IFB No. 19-13 Asbestos Abatement Project at Froberg and Hillman Schools

RE: **ADDENDUM NO. 1**

SUBJECT: ADDENDUM NO. 1 TO THE BIDDING DOCUMENTS

PROJECT MANUALS Rockford Public Schools District #205 – Hillman
Elementary School and White Swan Elementary School – Window
Replacement Asbestos Abatement dated December 7, 2018

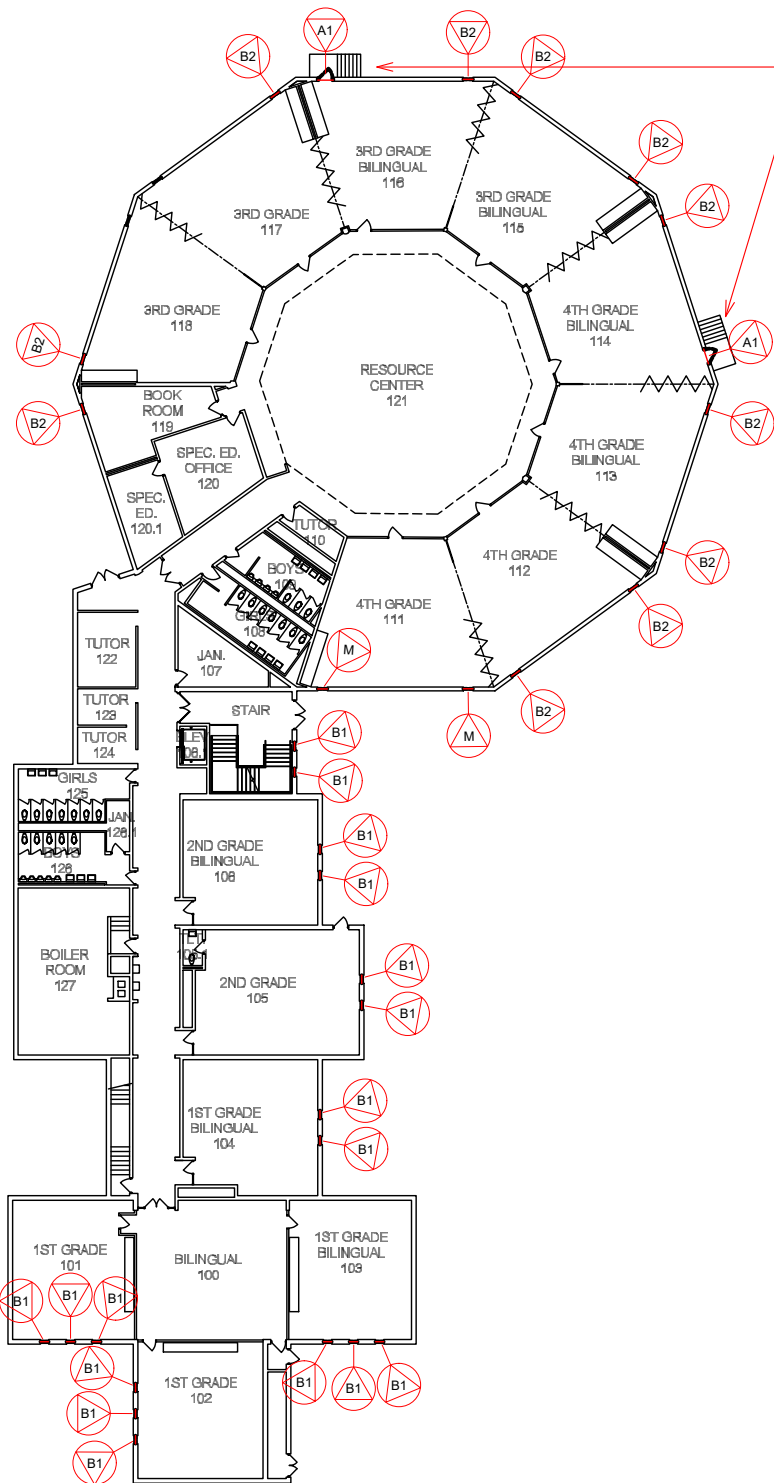
1. Froberg Elementary School – Additions to Scope of Work Drawings ASB-0 and ASB-1.
2. Hillman Elementary School – Additions to Scope of Work Drawings ASB-0, ASB-1, ASB-2.

- Base Bid Item 1: Exterior removal and disposal of existing window assemblies including the frames, and all asbestos-containing interior and exterior perimeter caulk, glazing compounds and putty as detailed in the environmental scope of work drawings ASB-1 through ASB-2.

- Base Bid Item 2: Removal and disposal of existing window assemblies, including the frames and all NON-ACM interior and exterior perimeter caulk, glazing compounds, putty, and Construction mastics.

- Alternate Bid Item 1: Removal and disposal of existing door, frames, associated hardware, and all NON-ACM caulking and sealants. Removal and disposal of approximately five (5) square feet of Asbestos-Containing flooring (All Layers) at the interior of each door opening.
